August 15, 2025

USD 321 Rossville High School Addition and CTE Renovation – JGR Proj #22-3269

ADDENDUM NO. 1

ME1.6

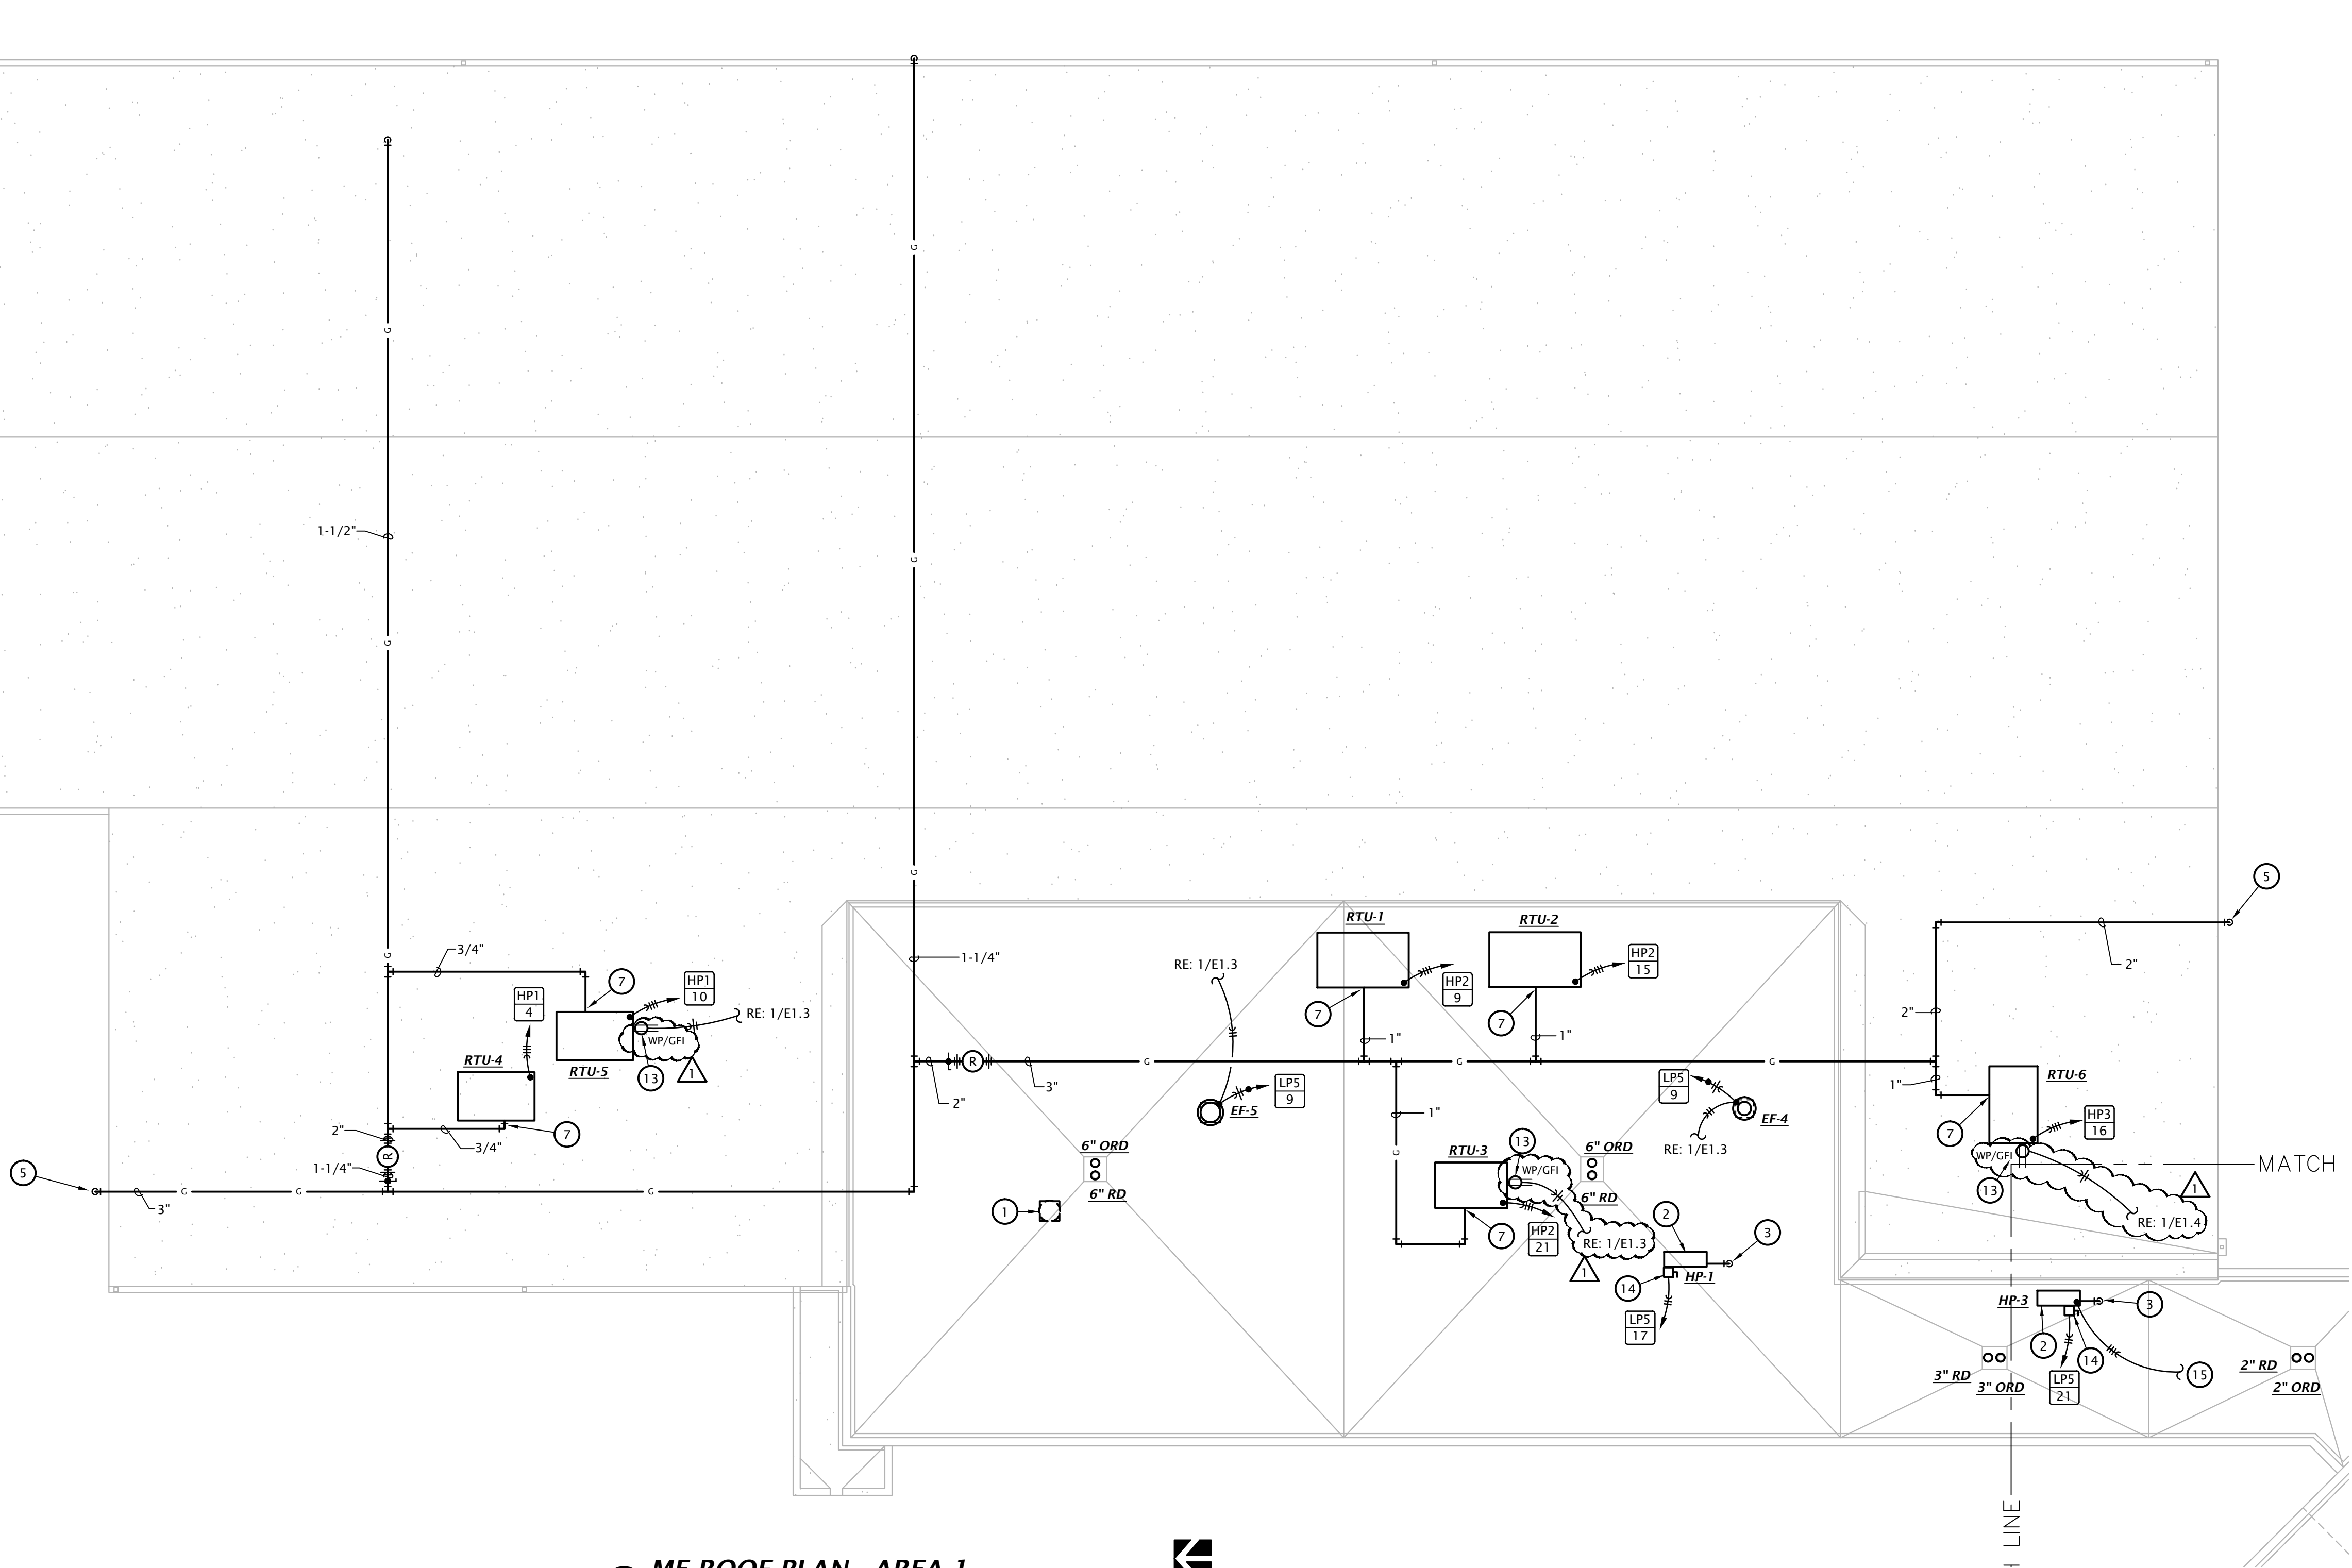
1. Sheet ME1.6: Added receptacles and circuitry to HVAC equipment.
2. Sheet ME1.7: Added receptacles and circuitry to HVAC equipment.
3. Sheet M1.1: Clarified notes for fixtures to be replaced.
4. Sheet M6.1: Updated schedule notes for roof top units.
5. Sheet M6.2: Added EW and WF to plumbing fixture schedule. Modified BS-B to trim only for integral bowl. Modified KS and BS-A to undermount sinks.

E1.5

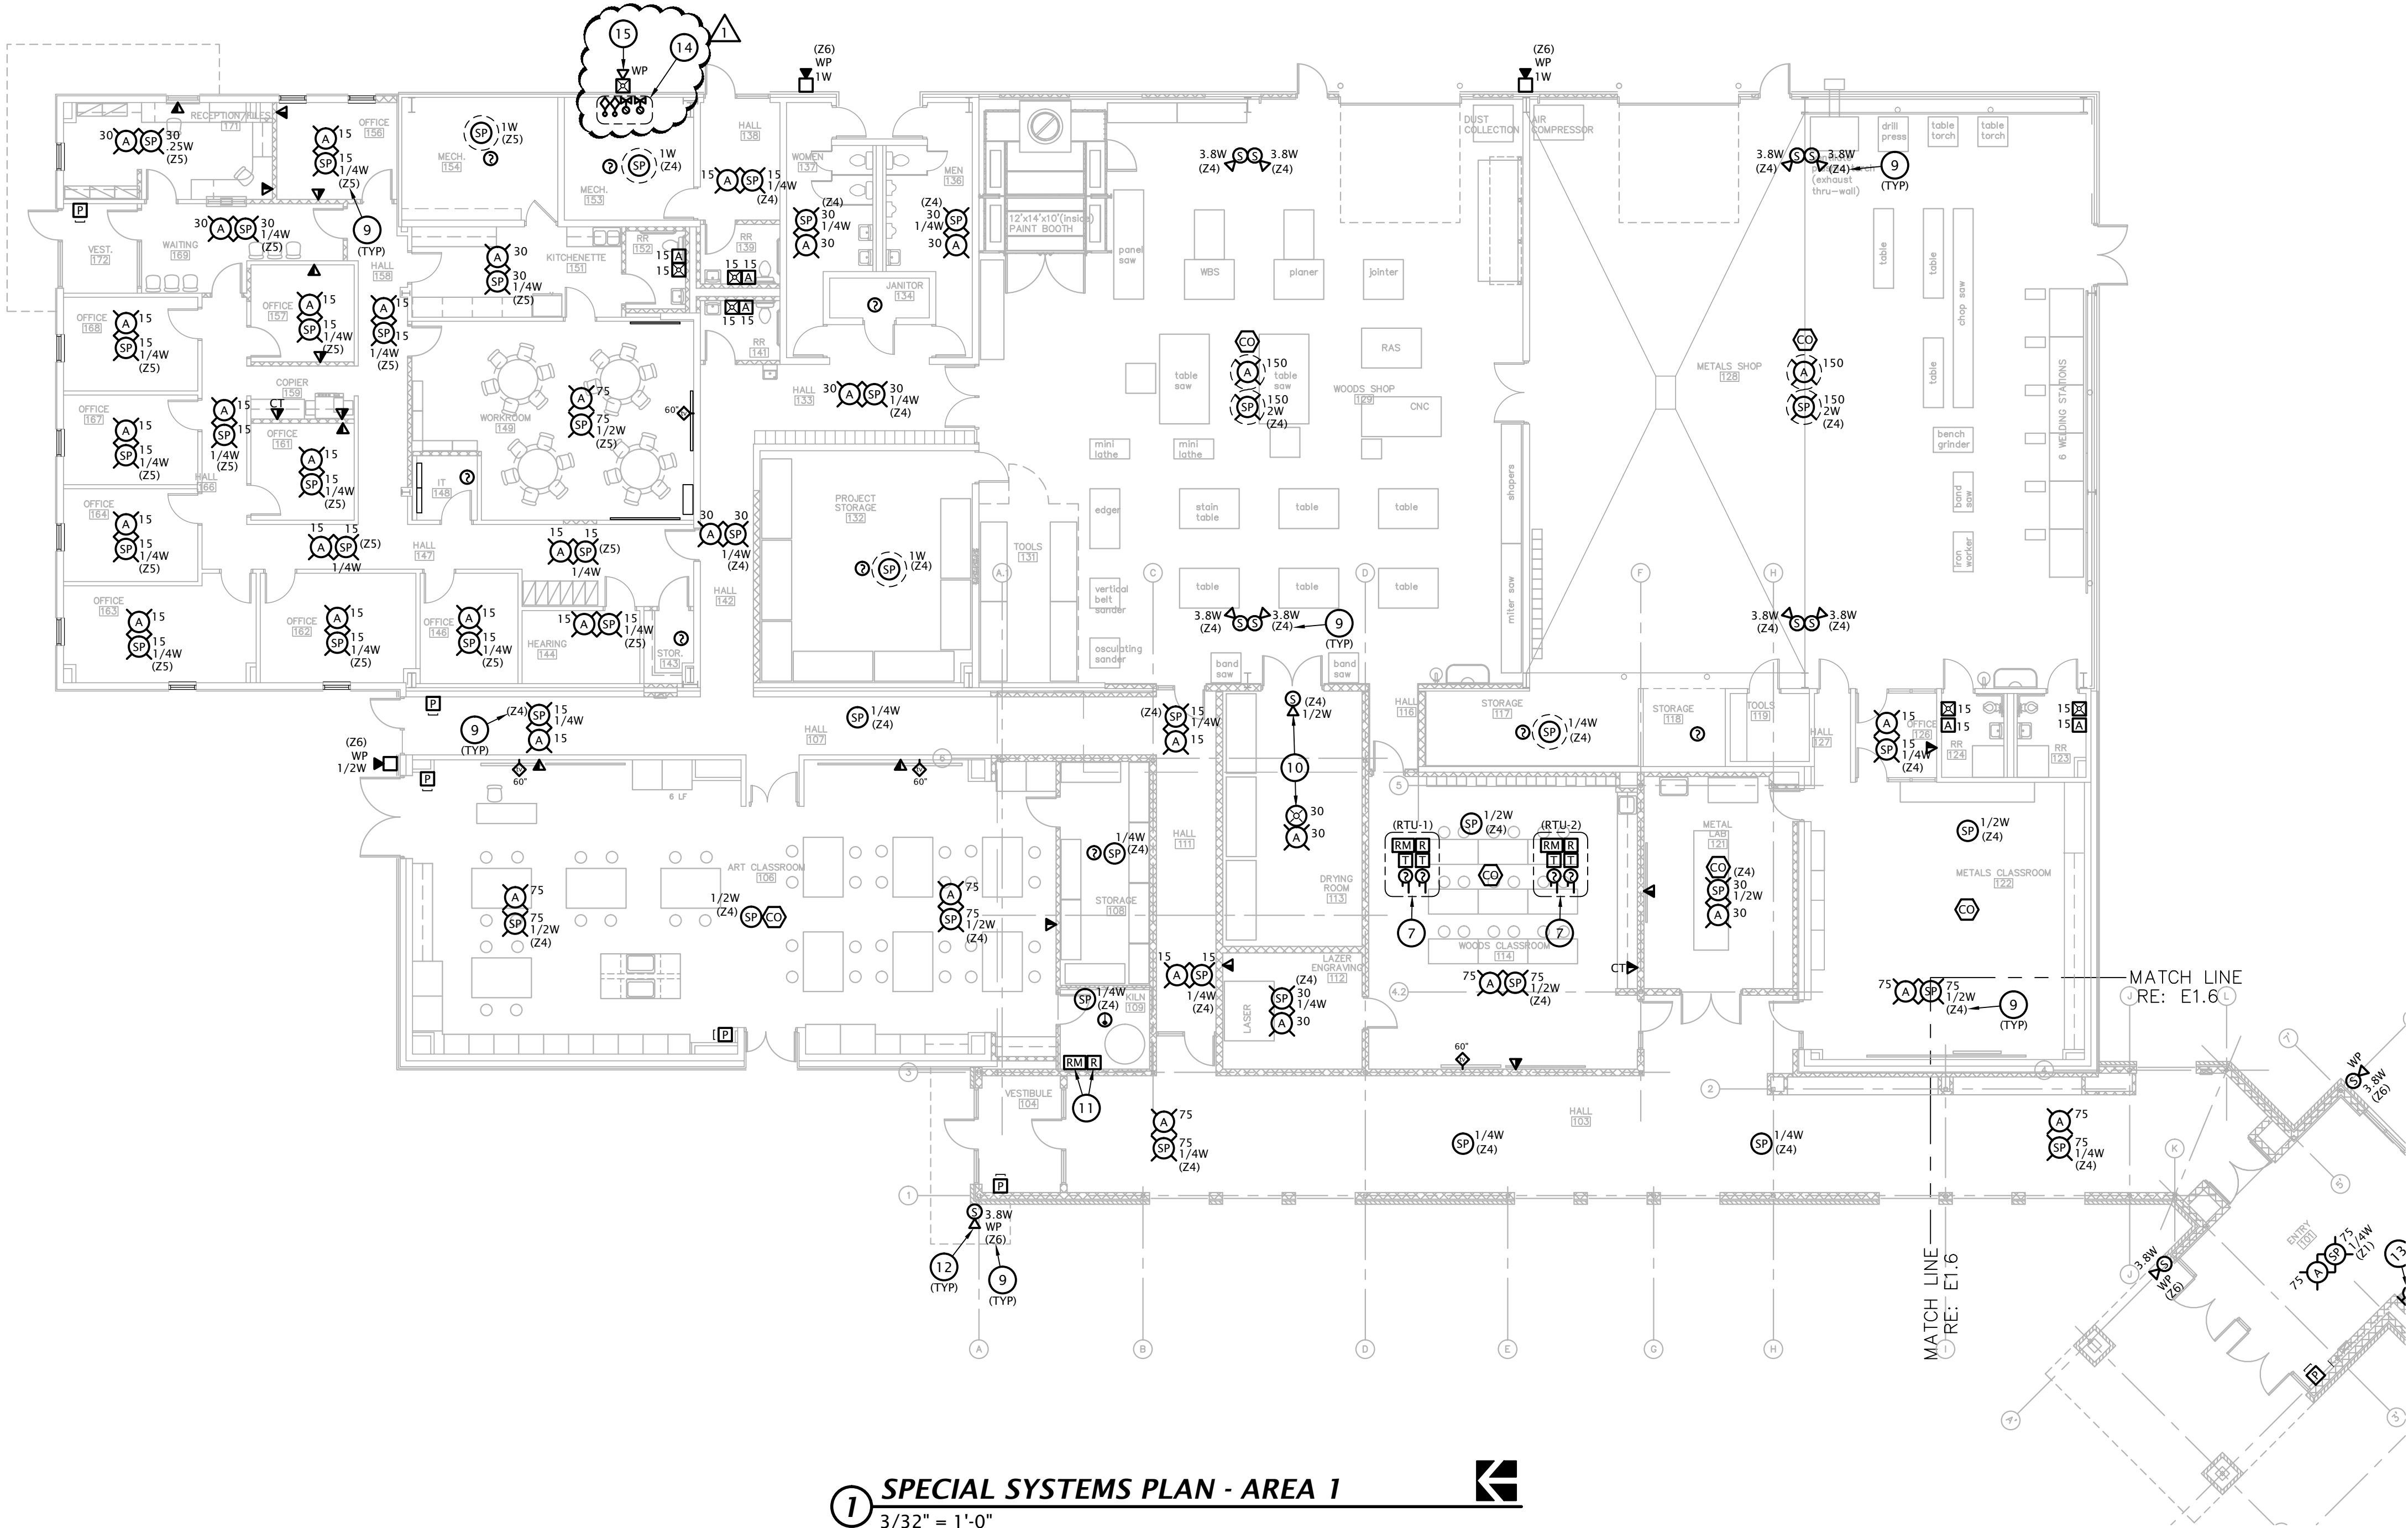
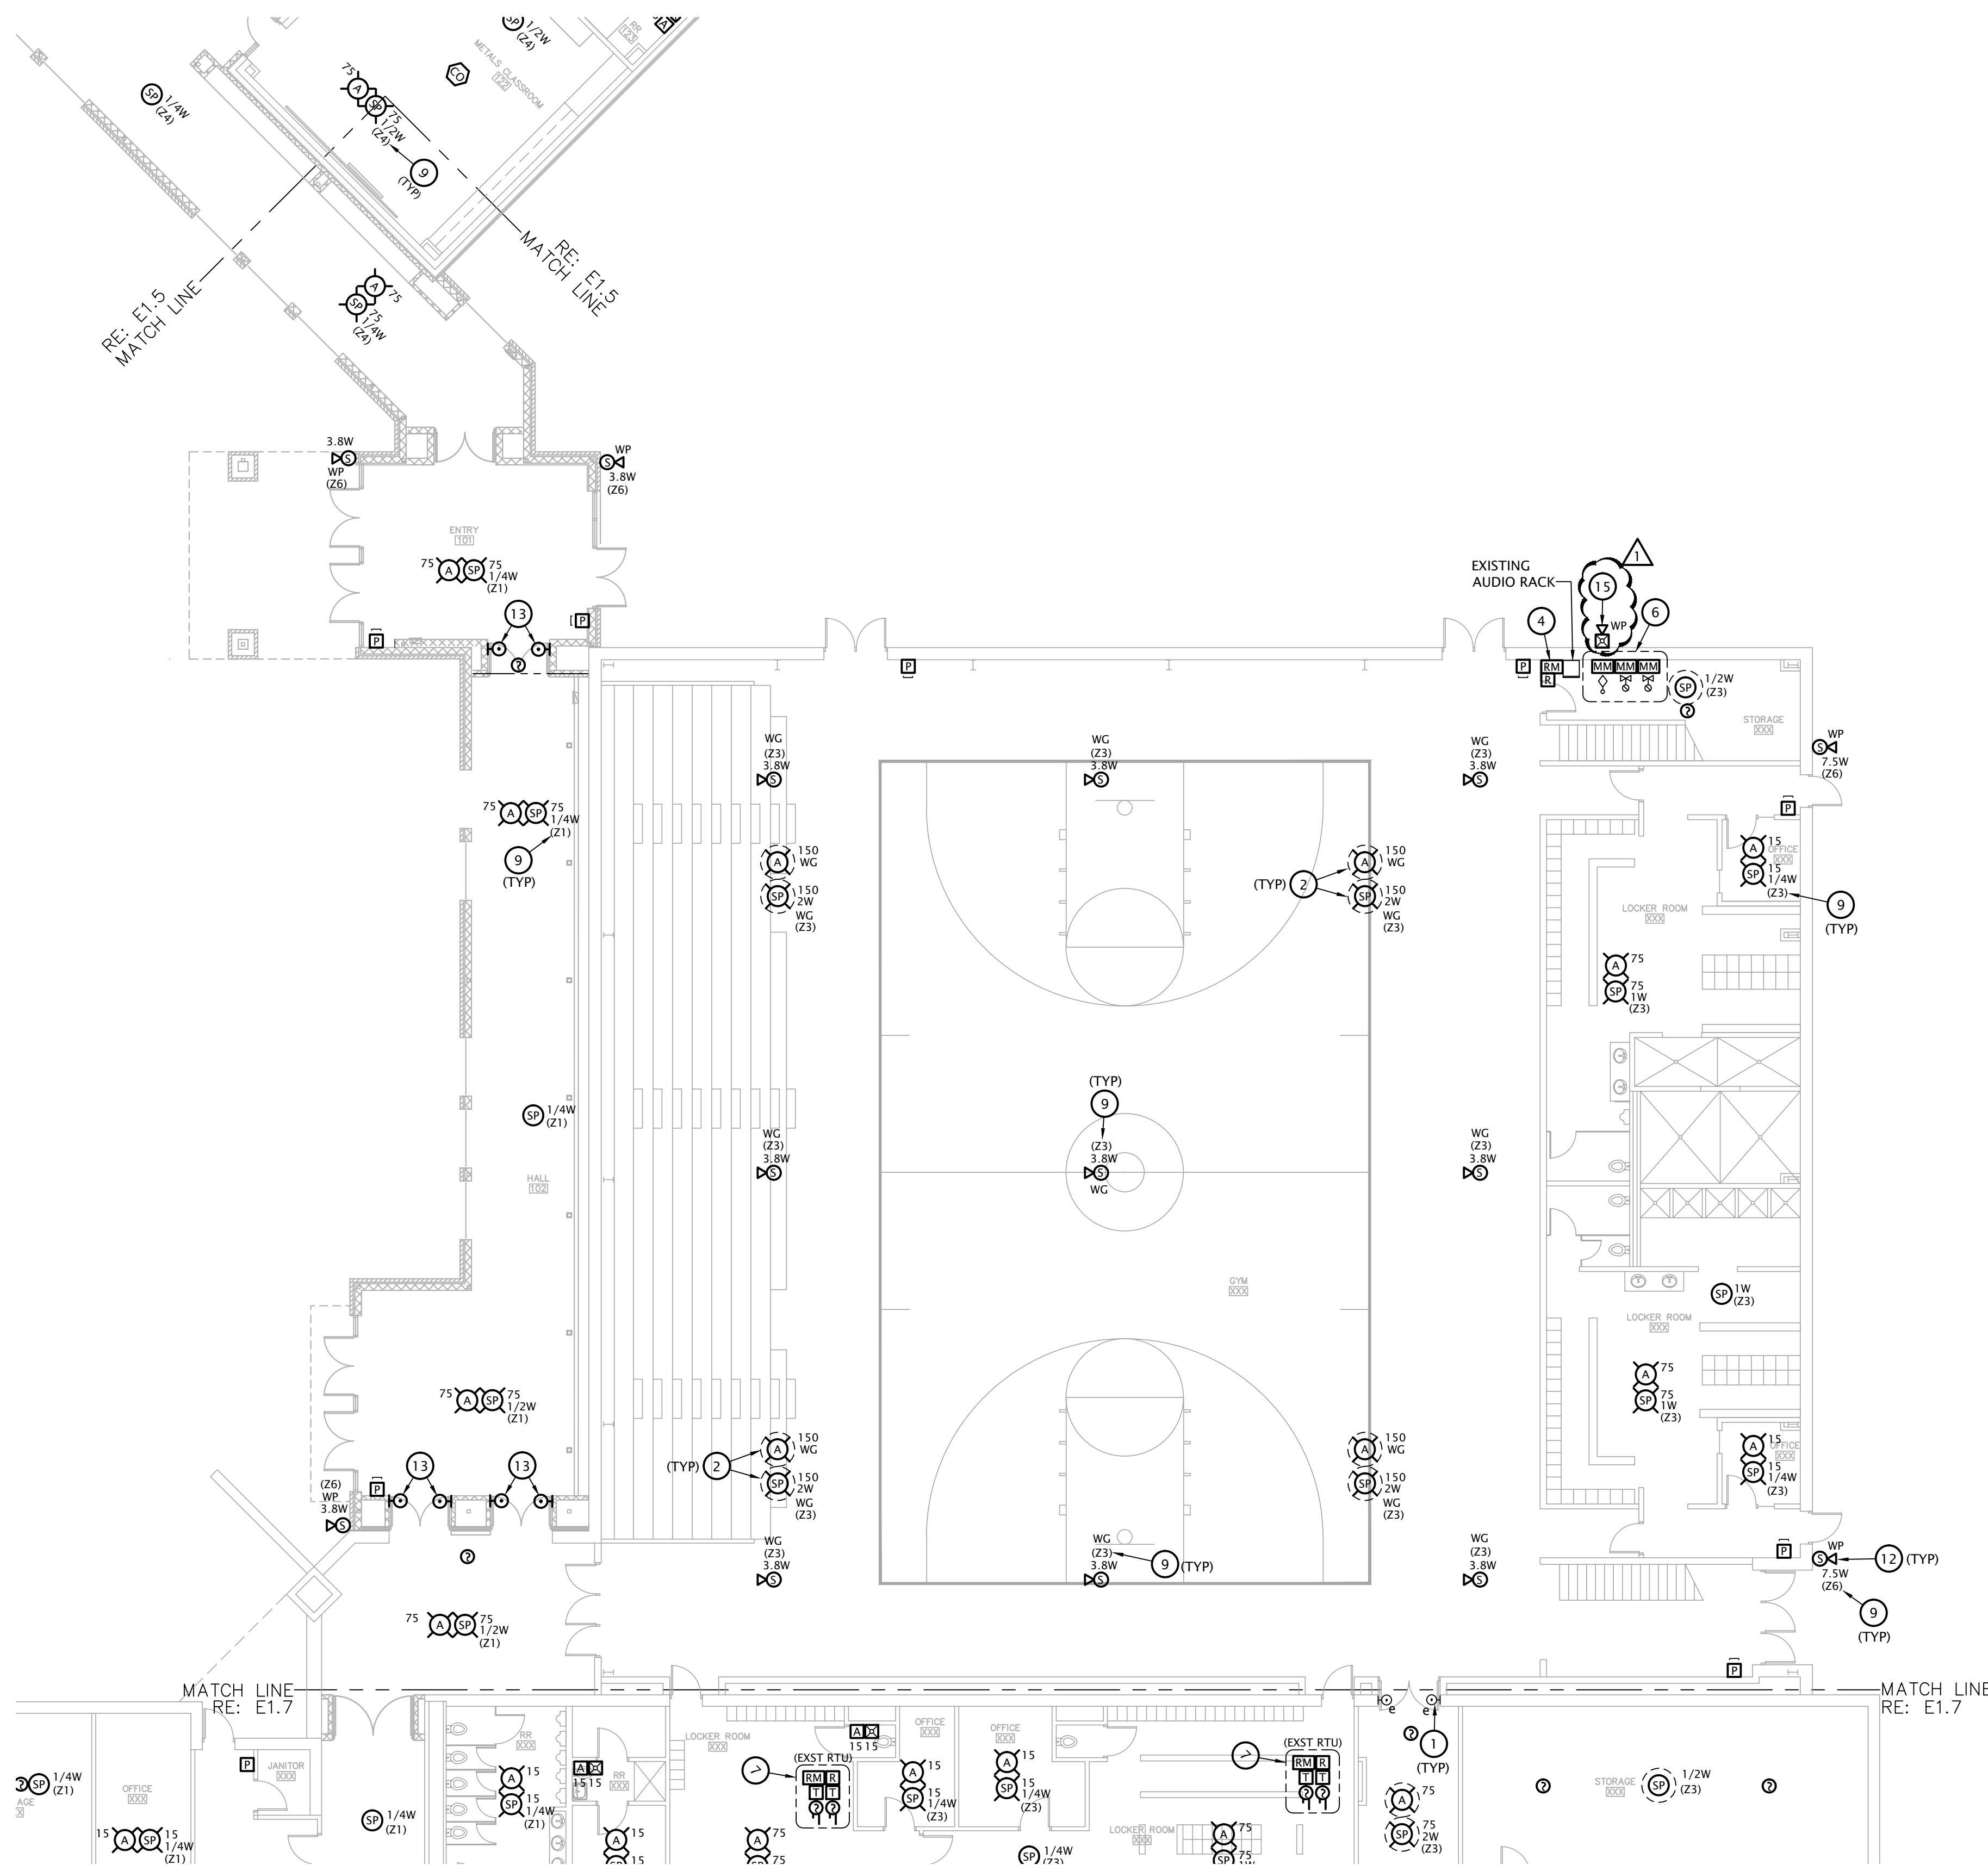
1. E1.3: Added notes to electrical items in Kiln Room.
2. E1.3: Added circuitry for roof mounted receptacle.
3. E1.4: Added circuitry for roof mounted receptacle.
4. E1.5: Added water flow and tamper switch monitoring at new fire sprinkler system riser.
5. E1.5: Added horn/strobe at exterior for new fire sprinkler system water flow alarm.
6. E1.6: Added horn/strobe at exterior for existing fire sprinkler system water flow alarm.
7. E1.8: Added horn/strobe at exterior for existing fire sprinkler system water flow alarm.
8. E6.2: Changed specification for light fixture types "G" and "H" in Light Fixture Schedule.
